COUNCIL ASSESSMENT REPORT

Panel Reference	2018CCI028
DA Number	688/2019/JP
LGA	The Hills Shire Council
Proposed Development	Demolition of Existing Structures and Construction of four 8-10 storey Residential Flat Buildings comprising 296 units (69 x 1 bedroom, 167 x 2 bedroom and 70 x 3 bedroom) and 407 car parking spaces within a basement car park.
Street Address	3-9 Fishburn Crescent, 14-16 Middleton Avenue and 37-45 Dawes Avenue Castle Hill
Applicant	Bridgestone Projects Pty Ltd
Owners	Mr J M Parsons, Mrs G S Parsons, Mr P S Hinding, Mrs C M E Hinding, Mr P A Cross, Mrs D Cross, Mrs J A Tindale, Mr W G Tindale, Mrs N Bertrand, Mr D W Hall, Mrs S Hall, Mr S Sroba, Mrs Z Sroba, Mr M A Gilchrist, Mrs M G Gilchrist, Mr S J Armsworth, Mrs D A Armsworth, Mrs M Scuglia, Mr V Scuglia and Mr Z Liu
Consultant/s	<p>Town Planner: Willowtree Planning Pty Ltd</p> <p>Architect: PTW Architects</p> <p>Landscape Architect: RPS Group</p> <p>Aboriculture: Naturally Trees Arboricultural Consulting</p> <p>Engineers: Adams Engineering</p> <p>Surveyor: Rygate Surveyors</p> <p>Acoustic: Acoustic Logic</p> <p>Traffic: The Transport Planning Partnership</p> <p>Quantity Surveyor:</p> <p>Wind Assessment: Ce

Figure 1. Original Height Plane (Source: PTW Architects, 2018)

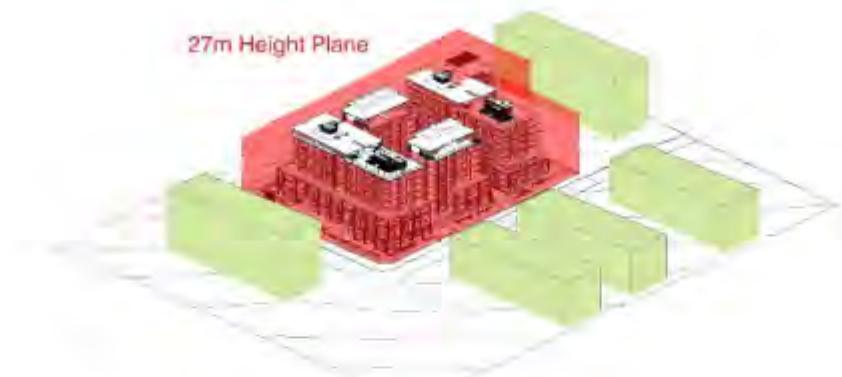
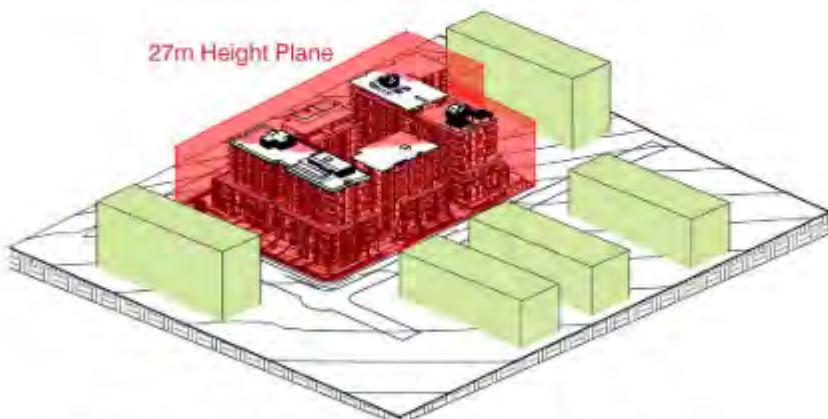
Figure 1 and **Figure 2** provides a comparative analysis of the extent of the variation from the **27m** height plane, between the original scheme and the amended scheme.

As illustrated in **Figure 2** above, the building mass over the height limit equates to **1.58%** (previously **4.2%**) of the overall building mass. In terms of gross floor area (GFA), **0.43%** of the total GFA of the development is located in the area which exceeds the maximum building height. The proposed development comprises a GFA of **28,557.91m²**, with approximately **122.79m²** being
